TAYLOR POINTE SUBDIVISION, UNIT ONE **RESUBDIVISION OF LOTS 44-47**

APPLICATION NUMBER 21 DATE February 21, 2008

DETAIL SITE PLAN

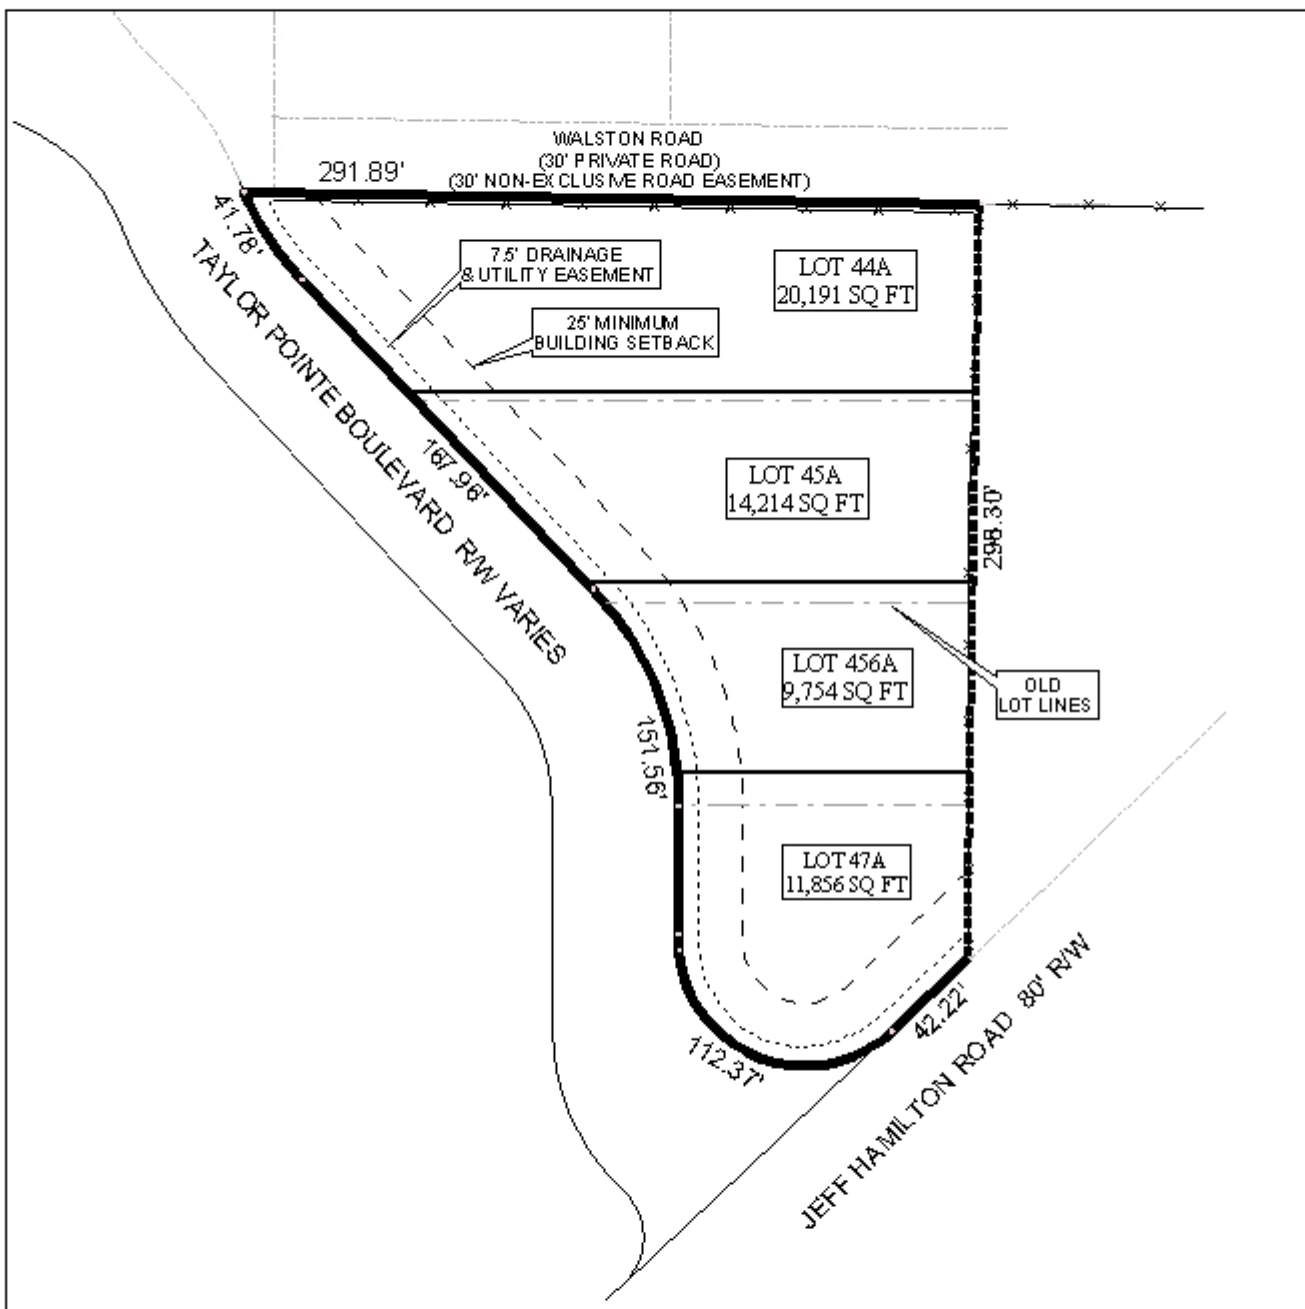
Unit One of Taylor Pointe Subdivision was recently recorded. The applicant now wishes to move the interior lot lines of Lots 44-47, thus changing the lot sizes. The site has approximately 355' of frontage along Taylor Pointe Boulevard, a new road with sufficient right-of-way. As a means of access management, each lot should be limited to one curb cut to Taylor Pointe Boulevard, and Lot 47A should be denied direct access to Jeff Hamilton Road.

The site is located in the county. Therefore, a note should be placed on the final plat stating that any lots developed commercially and adjoin residentially developed property must provide a buffer, in compliance with Section V.A.7. of the Subdivision Regulations.

While the site is located in the county, compliance with the City of Mobile storm water and flood control ordinances will be required. A letter from a licensed engineer certifying compliance with the City's storm water and flood control ordinances should be submitted to the Mobile County Engineering Department and the Planning Section of Mobile Urban Development prior to the issuance of any permits.

Based on the preceding, the plat meets the minimum requirements of the Subdivision Regulations and is recommended for Tentative Approval, subject to the following conditions:

- 1) placement of a note stating that each lot is limited to one curb cut to Taylor Pointe Boulevard, with the size, location, and design to be approved by County Engineering and conform to AASHTO standards;

- 2) placement of a note stating that Lot 47A is denied direct access to Jeff Hamilton Road;
- 3) placement of a note on the plat / site plan stating that the site must be developed in compliance with all local, state and Federal regulations regarding endangered, threatened or otherwise protected species;

- 4) placement of a note on the final plat stating that any lots developed commercially and adjoin residentially developed property shall provide a buffer in compliance with Section V.A.7. of the Subdivision Regulations; and

- 5) submission of a letter from a licensed engineer certifying compliance with the City of Mobile's storm water and flood control ordinances to the Mobile County Engineering department and the Planning Section of Mobile Urban Development prior to issuance of any permits.
